VIDEO PRODUCTION CENTER

Field Modification Note

REFERENCE ECO: 513M

Kalypso BIOS Upgrade and Hard Drive Replacement

Figure 5. Hard Drive on 4-M/E Main Panel

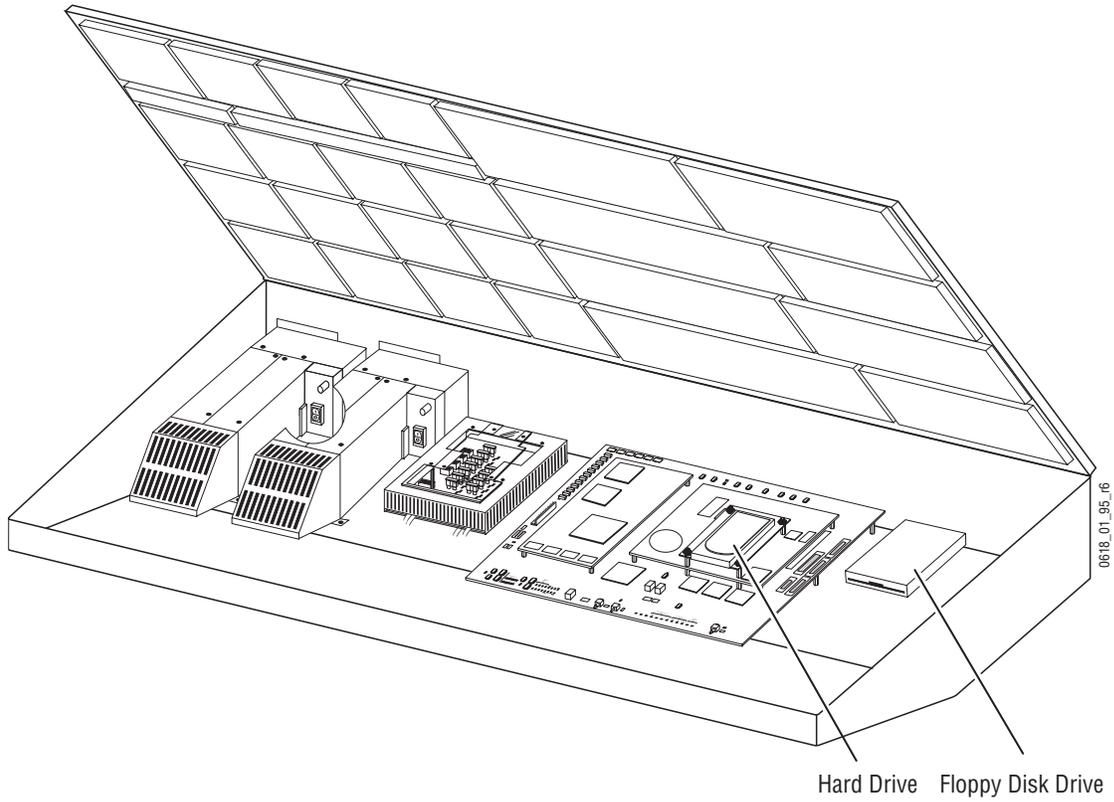
3. Locate the hard drive to be replaced on the 5811 Panel NT Processor Mezzanine Board.

Figure 8. Kalypso Main Panel Interior Showing 4 Mounting Plate Screws to Remove

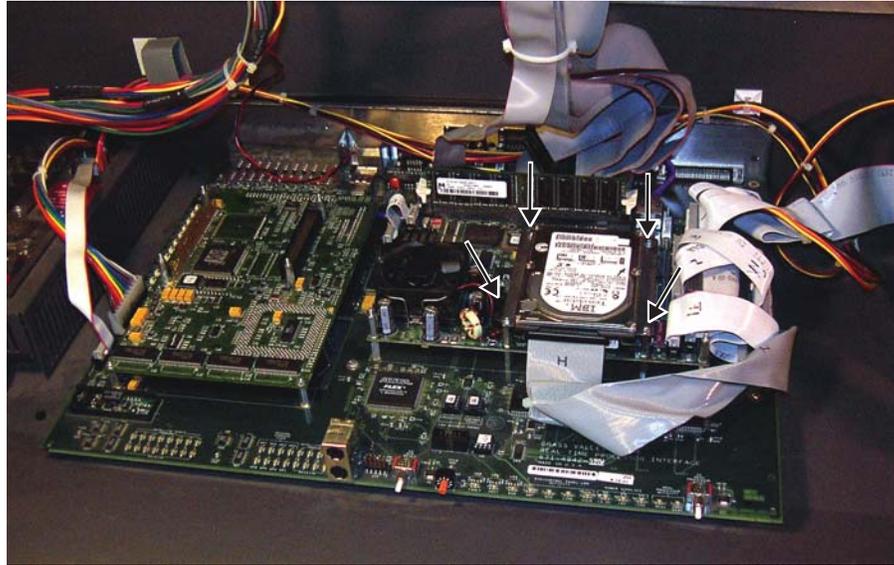
5. Remove the HD mounting plate from the board.
 - a. Using a 4-40 Nut driver remove the 4 nuts holding the HD mounting plate to the 5811 board, being careful not to lose the star washers.

- 8.** Install the new hard drive.
 - a.** Put the new hard drive on the plate and secure the 4 screws to hold the drive to the plate.
 - b.** Place the plate holding the hard drive back on the 5811 board.
 - c.** Replace the 4 washers and nuts and tighten them securely.
- 9.** Re-attach the ribbon cable to the hard drive.
